CORTZ APPARELS LTD (UNIT 2)

Extended Shed

Hakim master complex, Newjor, Kadda, Gazipur
(23.988479N, 90.363028E)
19 September 2021

Shed Building-1: (Single-story shed)

Horizontal bracing layout

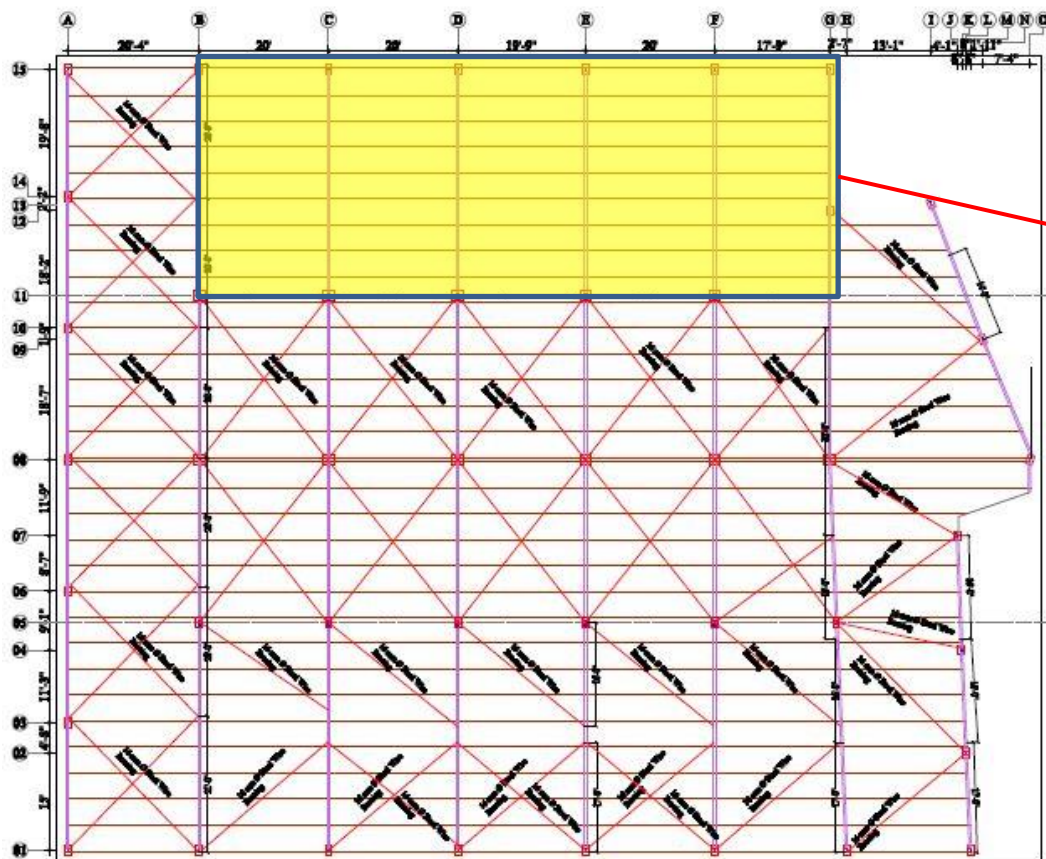
Discontinuity in load path

No bracing system

No bracing system provided at the highlighted area. Therefore, load path for lateral loading is not clear for this portion. Factory engineer is required to check the lateral stability system for the shed.

Horizontal bracing layout of retrofitting drawing

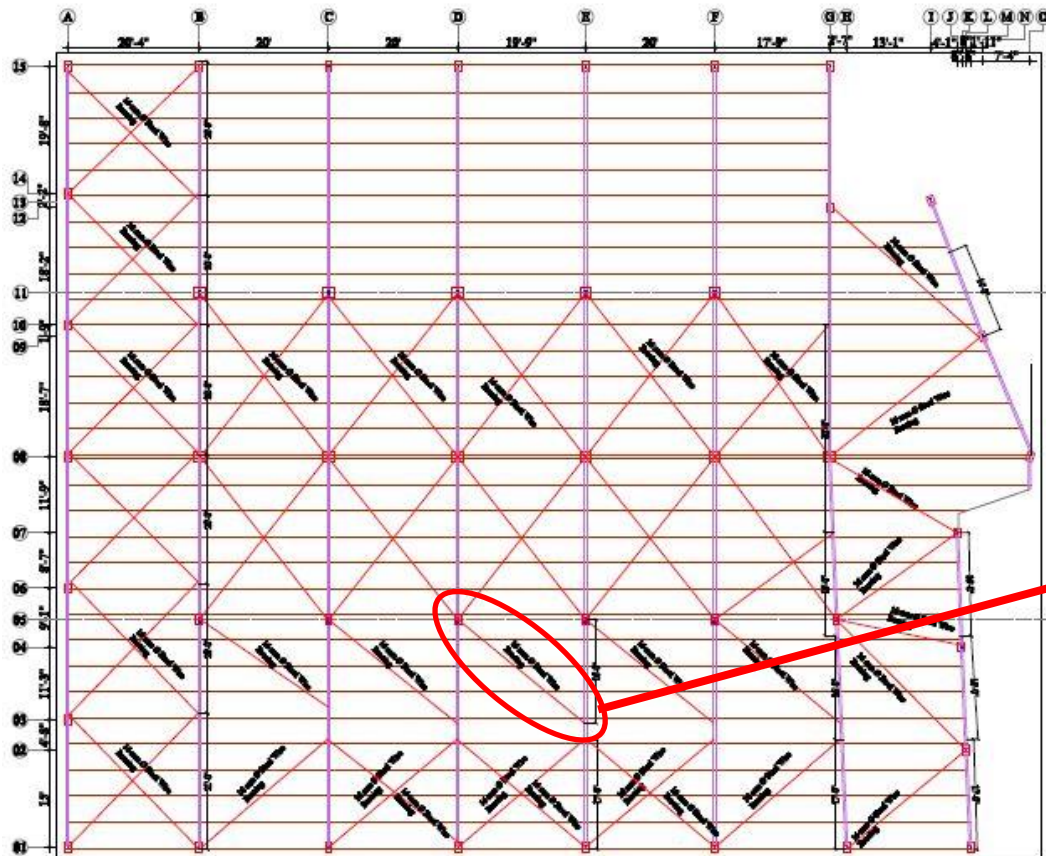
Missing horizontal & vertical bracing

Missing horizontal bracing at roof

Horizontal and vertical bracings at roof and wall were missing in the highlighted locations. Factory engineer is required to check the bracing requirements and install the bracings accordingly.

Vertical bracing layout

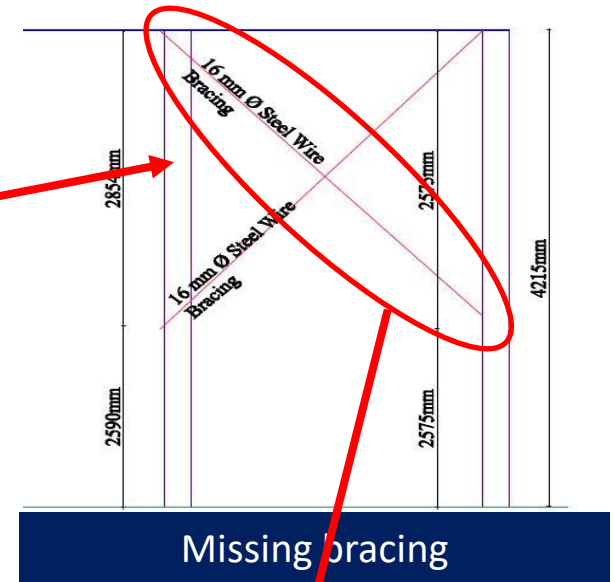
Missing bracing

Missing vertical bracing at wall
